UNIVERSITY OF CENTRAL FLORIDA

ADDENDUM

ITN NUMBER: 2024-10OCSA

ITN TITLE: Towers Buildings Summer Turns Painting

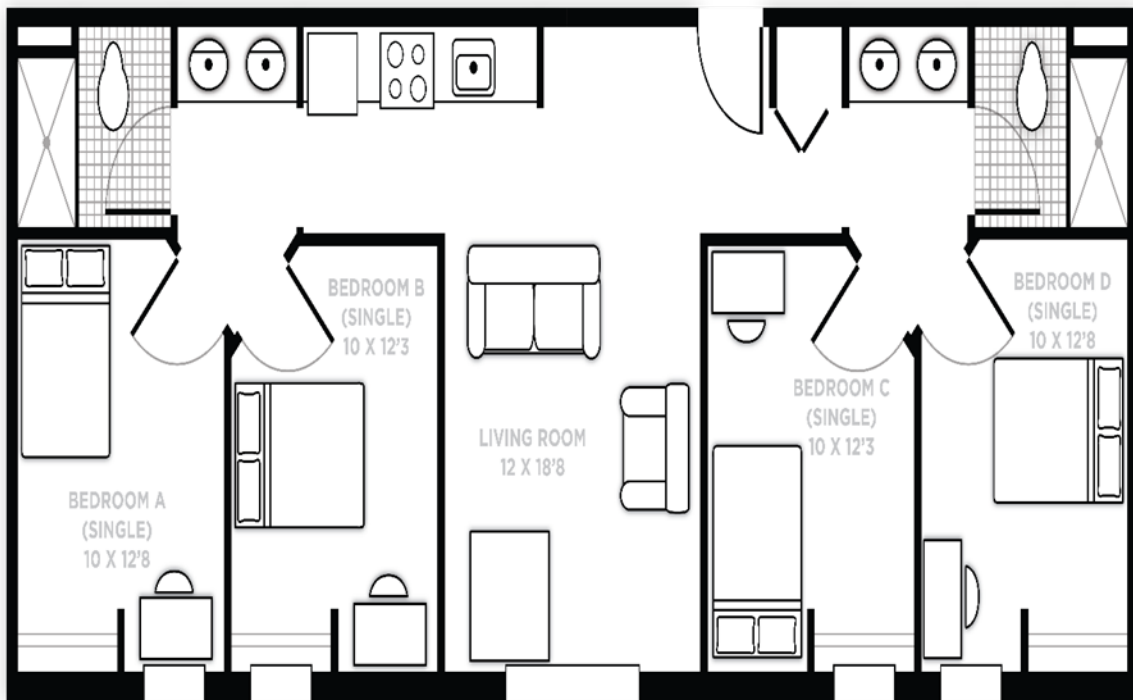
3. Vendor Question: If you have mop/janitorial sink areas, can we confirm their locations in each building?

UCF Answer: The mop sinks are located on each floor on the low numbered room side.
